FORM P3: ADMINISTRATIVE DECISIONS AND MINOR AMENDMENTS

RE: Minor Amendment to Site Development Plan-1004677/ 17EPC-40027, SI-2019-00152, PR-2019-002482, SI-2022-01668, PR-2022-007600

COUNTRY CLUB PLAZA I
1716 CENTRAL AVE., SW
ALBUQUERQUE, NM 87104

OVERALL SITE PLAN-
FOR ADMINISTRATIVE
AMENDMENT

B1 Partial Site Plan-Amenities Court
1"=10'-0"

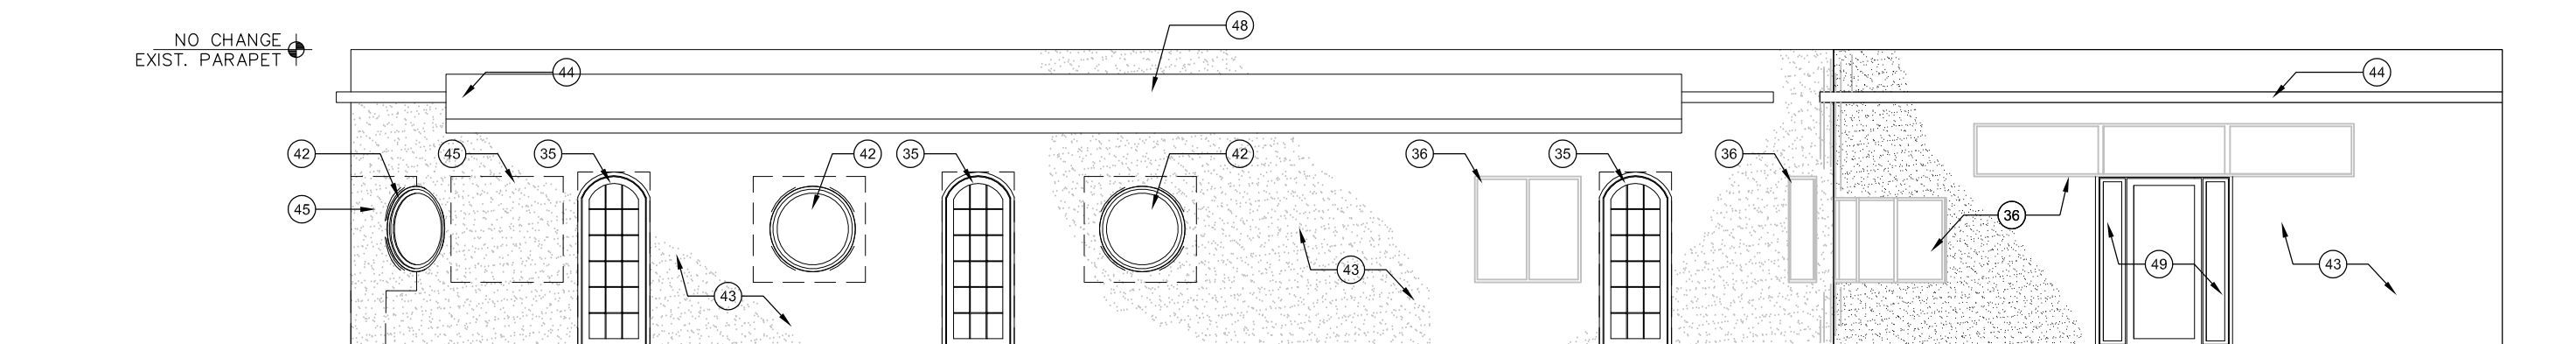
- Addition of 6'-0" and 4'-0" site walls along the northern property line at Central Ave. These walls, per IDO section 5-7 will require a variance as they exceed the maximum wall height as designated by table 5-7-1. See site plan and elevations for construction and finish. The architect is currently coordinating this variance with the ZHE. Project Number Pending. The proposed walls conform to the design standards designated by section 5-7(E) Materials and Design.

- New 4'-0" tall site walls along the Western edge of the approved open space. See plan and elevation for extent.
- A new pickle ball court surface. See Plan for location.

- A new steel shade structure (394 SF. covered). See elevations, and plans for extent and location.
- Designation of new outdoor seating area for the existing restaurant space. See plan for extent.

- New free-standing mobile (airstream trailer) concession stand. See Plan for location.

THE PURPOSE OF THIS MINOR AMENDMENT IS TO IMPROVE AMENITIES FOR THE
EXISTING RESTAURANT INCLUDING FACADE CHANGES TO SITE DEVELOPMENT.
CHANGES INCLUDE THE FOLLOWING:
- REPLACEMENT OF SQUARE WINDOWS WITH ROUND WINDOWS, RECTANGULAR
DOORS WITH ARCHED DOORS.
- THE ADDITION OF SITE WALLS TO PROVIDE SECURITY TO THE NEW
RESTAURANT.
- ADDITION OF 42" SLAT WALLS TO DEFINE SERVICE AREAS FOR OUTDOOR
SEATING
- THE ADDITION OF A NEW SHADE STRUCTURE

C3 Street Facing Facade (North) Glazing and Access Diagram
1/8"=1'-0"

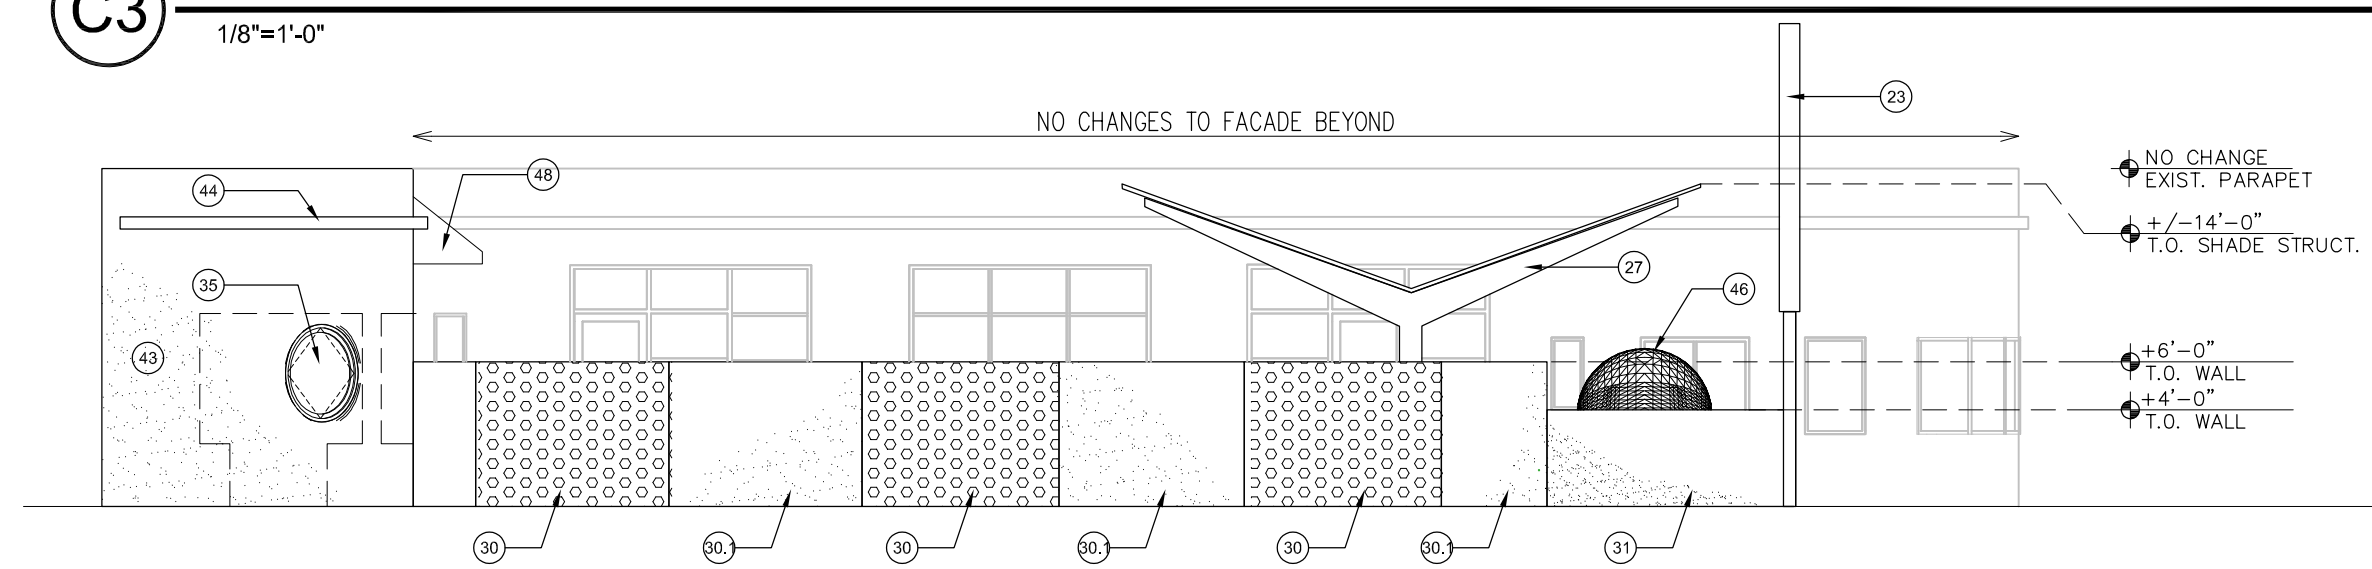
- The relocation of an access door on the north elevation of 1720 Central SW. Suite A. Replace with a 4'-0" circular window.
- The removal and replacement of various windows and doors along the western elevation of 1720 Central SW. Suite A. See plan and elevation for extent and style.
- The addition of one access door on the western façade of 1720 Central SW. Suite B- See plan and elevation.
- All stucco will be patched and repaired to match the existing façade.
- No change to color or texture is proposed in the Administrative Amendment.

Response: North elevations meet this requirement. See elevations.

Response: All Glazing on North façade opens onto usable space at a depth >6'.

Response: North façade includes the following 3 features:
